**Amendments to the Drawing:**

Attachment: New Sheet of Drawing

Fig. 3

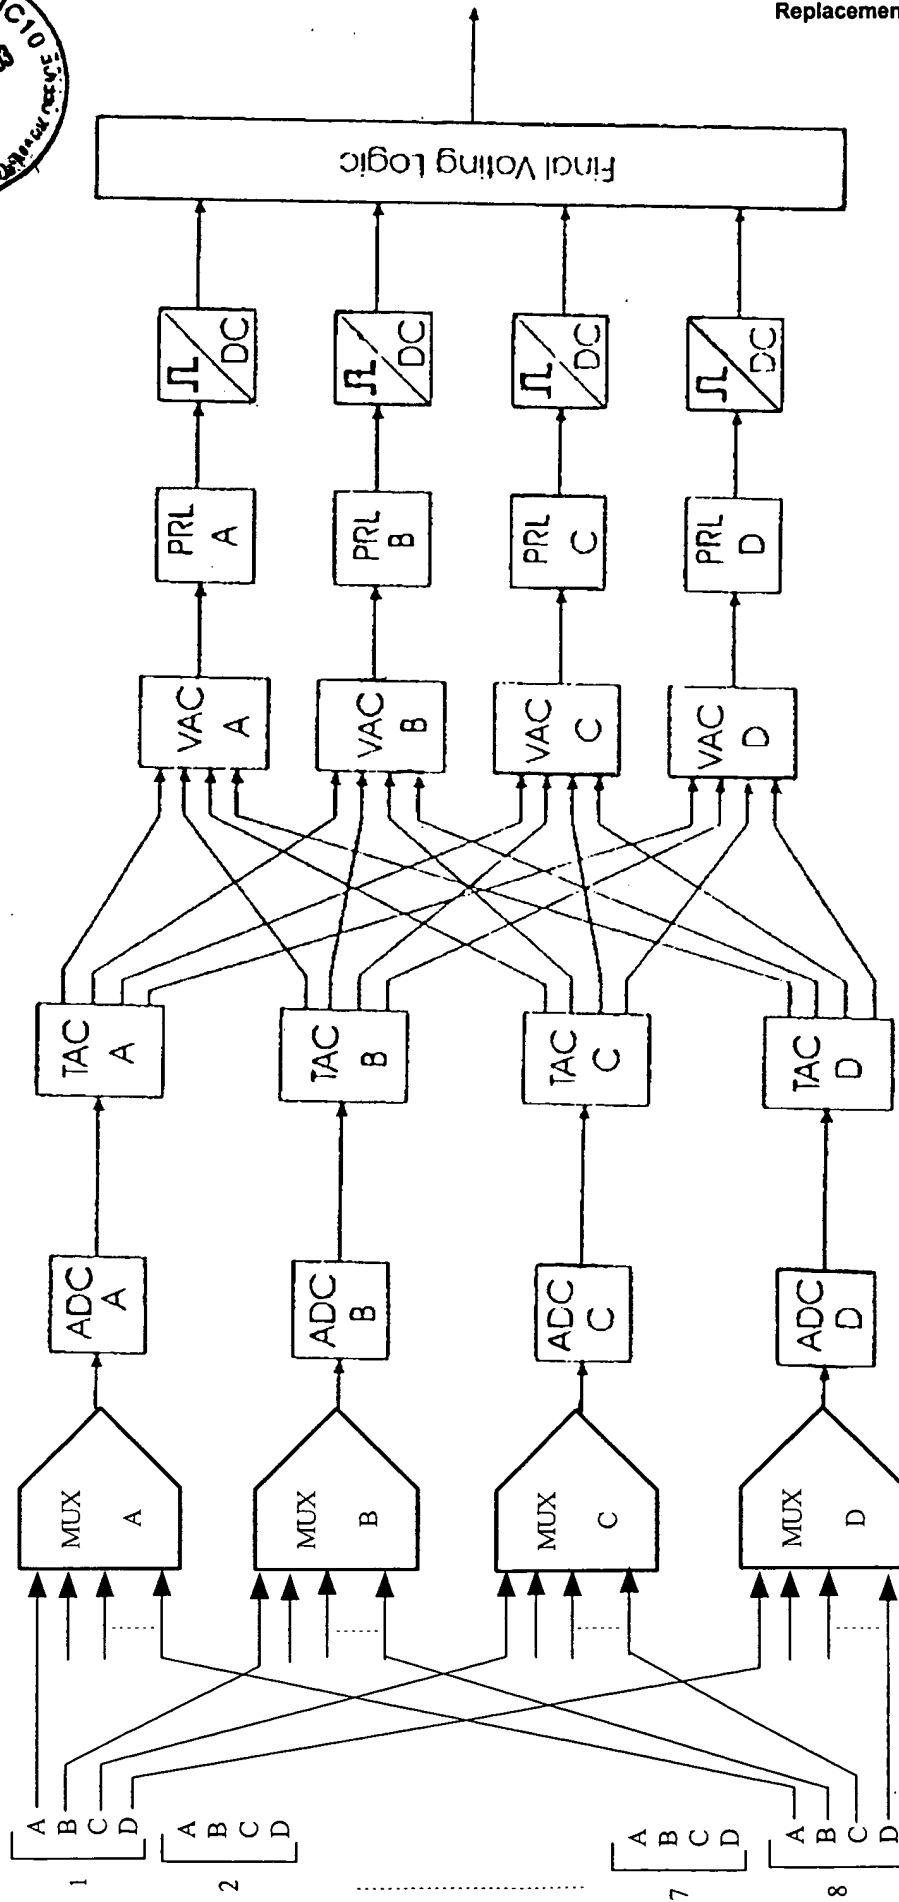
The attached sheet of drawing includes new Fig. 3, labeled "PRIOR ART". Support for Fig. 3 can be found in Fig. 2, column 3 with respect to a "DSS" system and as described in the Specification as a "conventional dynamic safety system (DSS) that has four independent measuring channels." Accordingly, no new matter is added by the addition of Fig. 3.
